**Subject: Response to Portion of NRC Request for Additional Information  
Letter No. 49 Related to ESBWR Design Certification Application –  
TRACG Application for ESBWR Stability Evaluation and NEDC-  
33239P, “GE14 for ESBWR Nuclear Design Report” – RAI Numbers  
4.4-14 and 21.6-54**

**Response to Portion of NRC Request for Additional  
Information Letter No. 49**

**RAI Numbers 4.4-14 and 21.6-54**

Figure 1-1 from NEDC-33239P

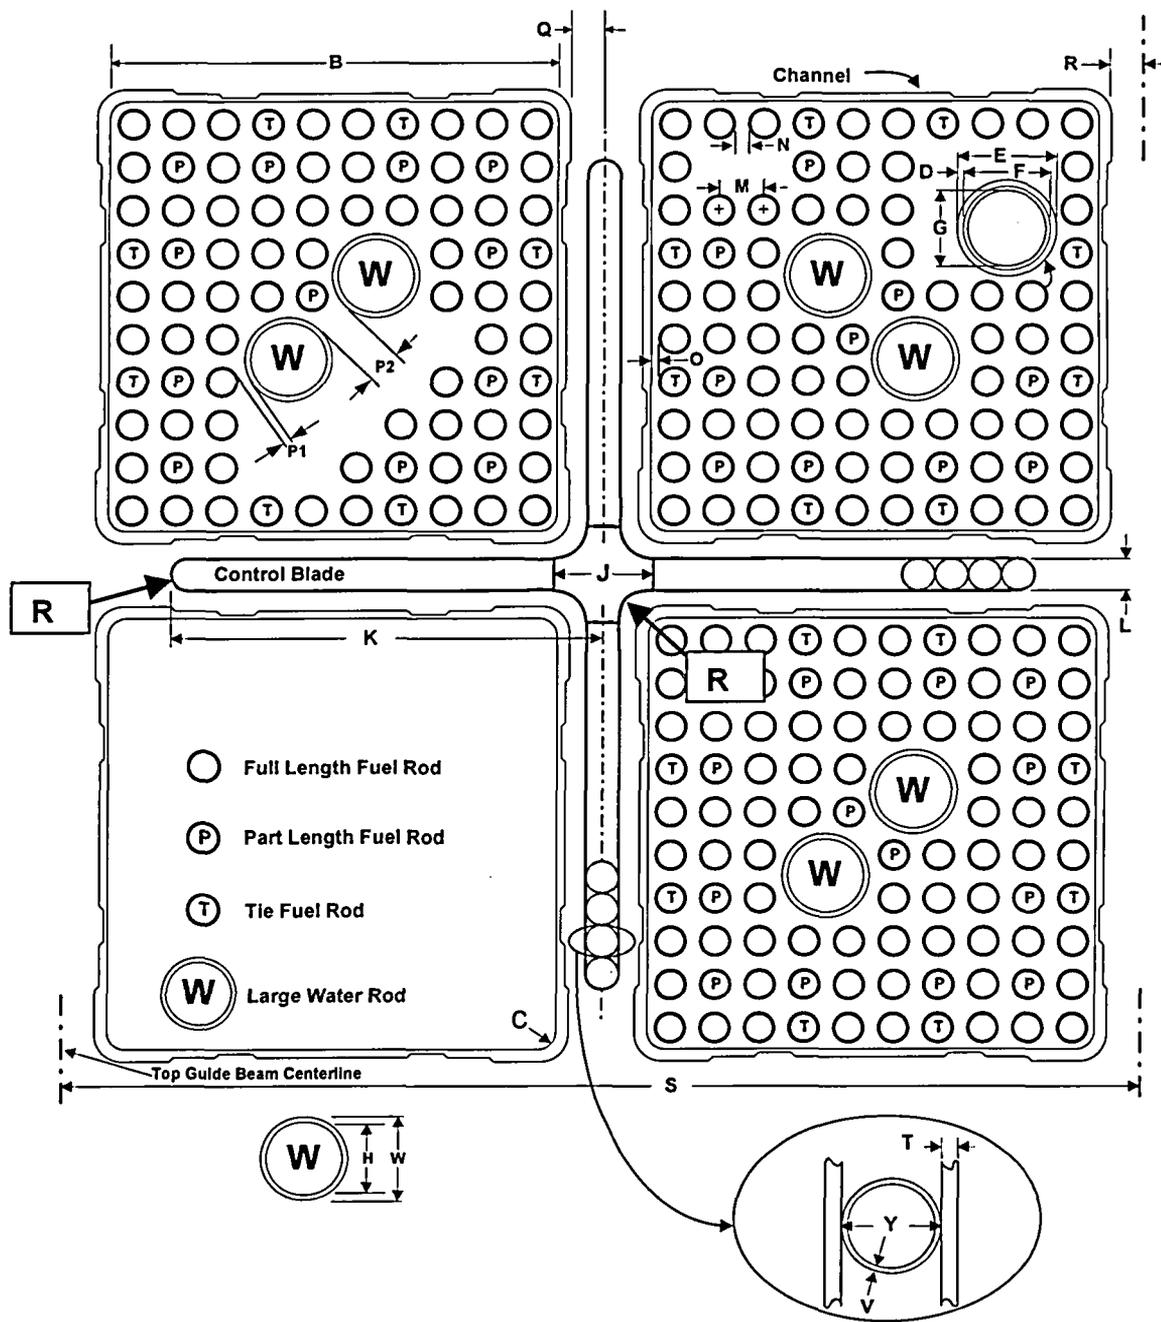
- E. Bundle structural materials and associated densities*
- F. Dimensions, compositions, densities and typical operating temperatures for the control rods*

- G. Dimensions for the letters in diagram in Figure 1-1 for bundles 90018 and 90019*
- H. Additional information defining exactly what is meant by the terms "shutdown margin" and "control rod worth"*

The following figure is Figure 1-1 from NEDC-33239P. The dimensions with respect to the nomenclature:

- K = 12.45 cm, ½ span of control rod.
- J = 3.937 cm, central support span (i.e. tie rod span).
- L = 0.8331 cm, control rod wing thickness
- T = 0.1143 cm, sheath thickness
- Y = 0.5588 cm, absorber tube outer diameter
- V = 0.06858 cm, absorber tube thickness
- R1 = 0.0762 cm, central support span radius
- R2 = 0.41656 cm, control rod wing tip radius
- 18 = number of B<sub>4</sub>C absorber rods per wing

G. See the following table 21.6-54-1. Dimensional data for bundles 90019 and 90018 are taken from NEDC-33239P Figures 3-2, 3-3, 3-5, and 3-6.
